## United States Patent and Trademark Office

APPLICATION NO.	FILING DATE	FIRST NAMED INVENTOR	ATTORNEY DOCKET NO.	CONFIRMATION NO.
10/775,540	02/10/2004	David R. Maas	13506-015001	6695
26191 7590 01/09/2007 FISH & RICHARDSON P.C. PO BOX 1022			EXAMINER	
			BATSON, VICTOR D	
MINNEAPOLIS, MN 55440-1022			ART UNIT	PAPER NUMBER
	·		3671	
SHORTENED STATUTORY PERIOD OF RESPONSE		MAIL DATE	DELIVERY MODE	
3 MONTHS		01/09/2007	PAPER

Application No.	Applicant(s)				
Office Action Summary		10/775,540	MAAS ET AL.				
		Examiner	Art Unit				
		Victor Batson	3671				
Period fo	The MAILING DATE of this communication app or Reply	pears on the cover sheet with the c	correspondence address				
WHIC - Exter after - If NO - Failu Any I	ORTENED STATUTORY PERIOD FOR REPL' CHEVER IS LONGER, FROM THE MAILING DA ASSISTANT ASS	ATE OF THIS COMMUNICATION 36(a). In no event, however, may a reply be tin will apply and will expire SIX (6) MONTHS from the cause the application to become ABANDONE	N. nely filed the mailing date of this communication. D (35 U.S.C. § 133).				
Status

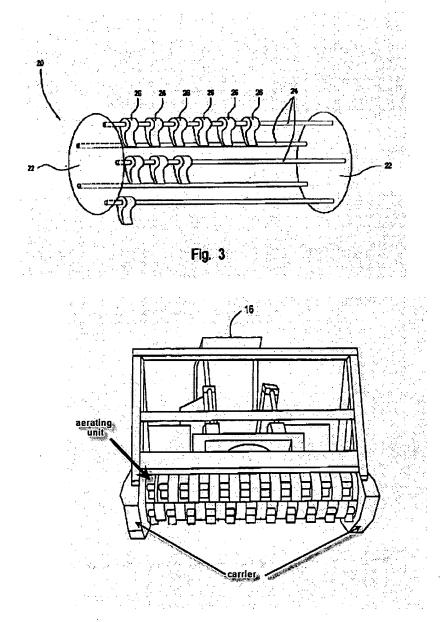
Claims 1,2,6,11,12,13,15,16,17 are rejected under 35 U.S.C. 102(b) as being anticipated by Edwards (6,484,811).

Edwards discloses an apparatus comprising first and second holding means 24 coupled to a carrier, with staggered first and second soil fracturing means 26 capable of fully rotating about their holding means without interference as shown in figure 3. It is noted that the aerating unit 20 during use is rotatably mounted in a carrier (see modified figure below). It is further noted that aerating unit 20 includes first and second shafts 24 (see modified figure 3 below). Therefore, Edwards is considered to meet the limitation of "first and second shafts rotatably coupled to a carrier". Additionally, Edwards in column 1 lines 42-45, specifically states that centrifugal force causes each of the hammers 26 to pivot radially beyond the limits of each spacer 27, and is therefore considered to meet the limitation of each tine fully rotating about the shaft.

Applicant's arguments filed 10/13/06 have been fully considered but they are not persuasive. Applicant argues regarding claim 1 that Edwards fails to disclose or suggest first and second shafts rotatably coupled to a carrier because the support rods 24 of Edwards are affixed to end plates 22. The examiner notes however that end

plates 22 are not considered the carrier (see modified figure above with carrier identified). Applicant argues regarding claim 11 that Edwards fails to disclose that during operation of the apparatus, the first soil fracturing means fully revolves about the first holding means relative to the carrier, because Edwards discloses that the cutting hammers 26 are enclosed by sector shaped spacers 27 that limit the hammers 26. The examiner notes however that Edwards further discloses that centrifugal force causes each of the cutting hammers 26 to pivot <u>radially beyond</u> the limits of each spacer 27 (see column 1 lines 42-45). Additionally, Edwards discloses that cutting hammers 26 are freely rotatable about the support rods 24, and are sometimes referred to as "flail" mulchers or mowers (see column 1 lines 57-59).
